SERVICE PROCEDURE

**G-10519
JANUARY 2011**

**SUBJECT: SAFETY RECALL
ENGINE TURBO OIL SUPPLY LINE on certain CE
model school buses built 2/25/10 thru 9/20/10 with
a MaxxForce DT engine**

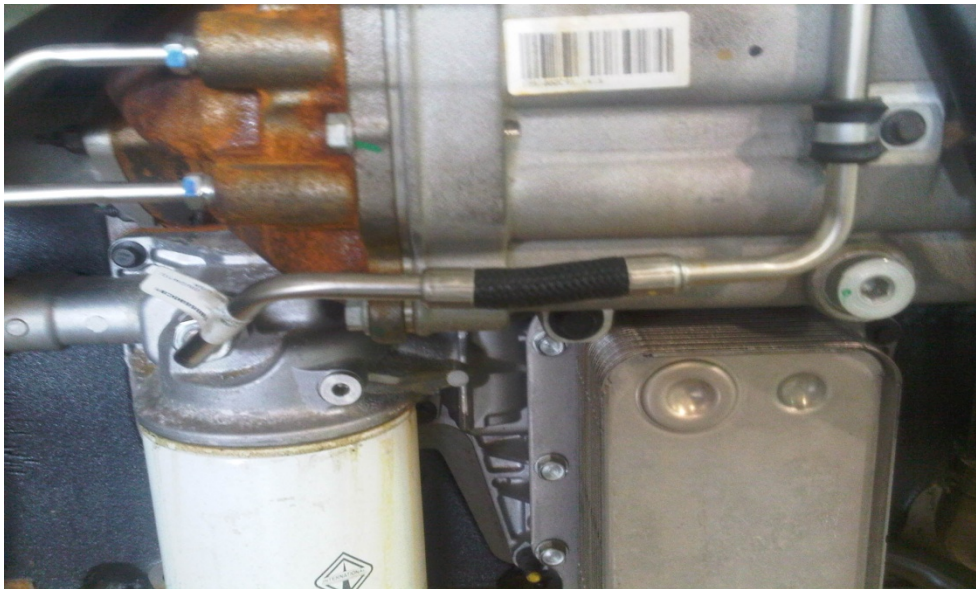
1. Disconnect the MAF sensor connector.

2. Loosen the air box ducting clamps, slide air compressor feed hose clamp to where hose can be removed from 90 degree fitting.

Note: For CE Bus model, removal of the air cleaner is not necessary.
